Subject: Addendum 2 for: US-70 Sidewalk Gap Project

CONTRACT No: DM00055
TIP: ER-2971
FA: 000S-424
WBS: 3613.3.07
COUNTY: Buncombe
ROUTE: US-70

PRECAST GRAVITY RETAINING WALL WITH CAST-IN-PLACE SIDEWALK AND HANDRAIL

PRECAST GRAVITY WALL WITH PRECAST TOP UNIT AND CAST-IN-PLACE SIDEWALK - TYPICAL SECTION

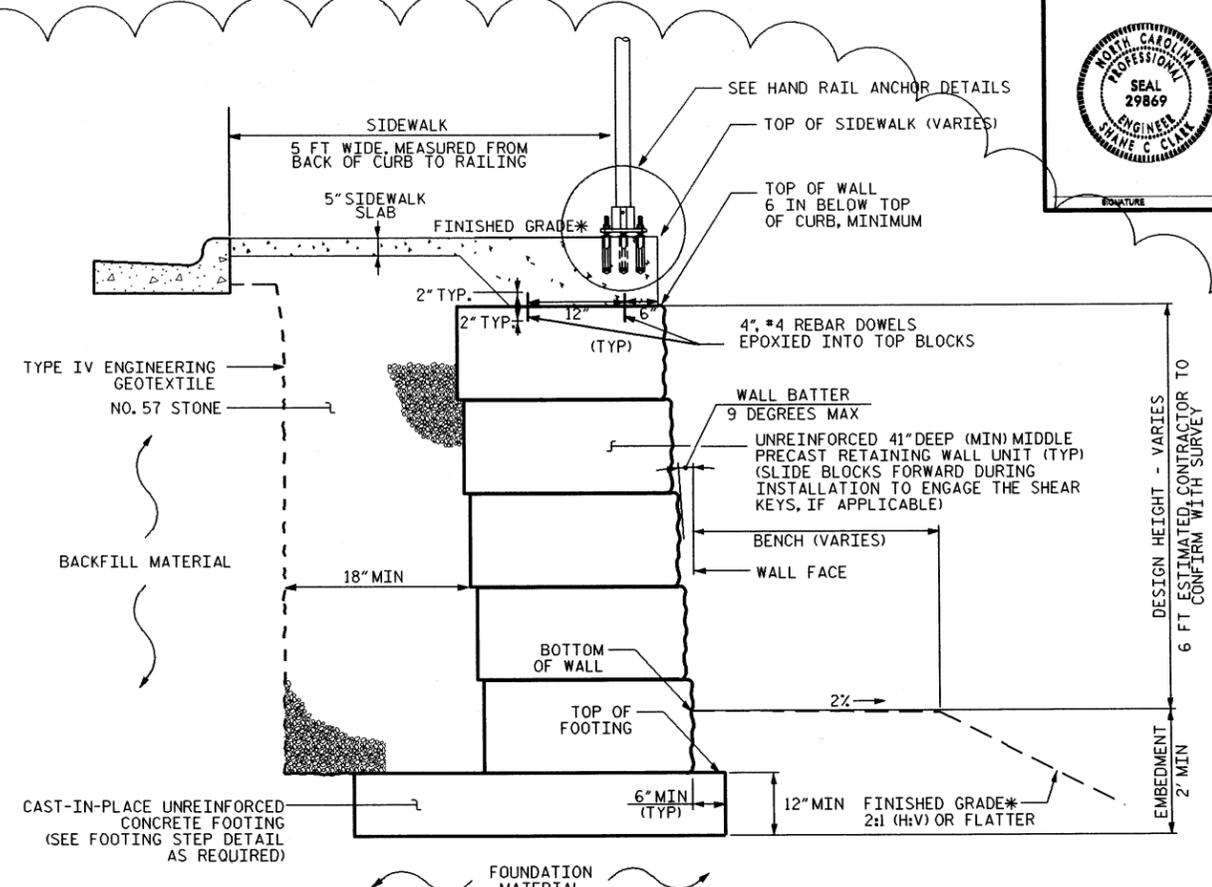
- The Retaining Wall Detail for the subject project states that Redi-Rock block is to be used for construction of the gravity retaining wall. This wording has been removed from the Retaining Wall Detail. Upon award of contract the contractor shall submit documentation as to the type of precast block and manufacturers installation methods to NCDOT for review and approval/rejection based on the revised special detail. Please note this change when bidding this project.

USE PRECAST RETAINING WALL UNITS WITH A COBBLESTONE FACE FINISH. PROTECT BLOCKS AS REQUIRED TO PREVENT DAMAGE. DAMAGED, CHIPPED, OR DISCOLORED BLOCKS MAY BE REJECTED BY THE ENGINEER AND REPLACED AT NO ADDITIONAL COST TO THE DEPARTMENT.

ALTERNATE BLOCK SIZES MAY BE CONSIDERED, HOWEVER ADDITIONAL DESIGN DOCUMENTATION MAY BE REQUIRED. THE SYSTEM DESIGN SHOULD INCLUDE A TRAFFIC SURCHARGE OF 250 PSF AND BE CONSIDERED STABLE ACCORDING TO THE LATEST EDITION OF THE AASHTO LRFD BRIDGE DESIGN SPECIFICATIONS.
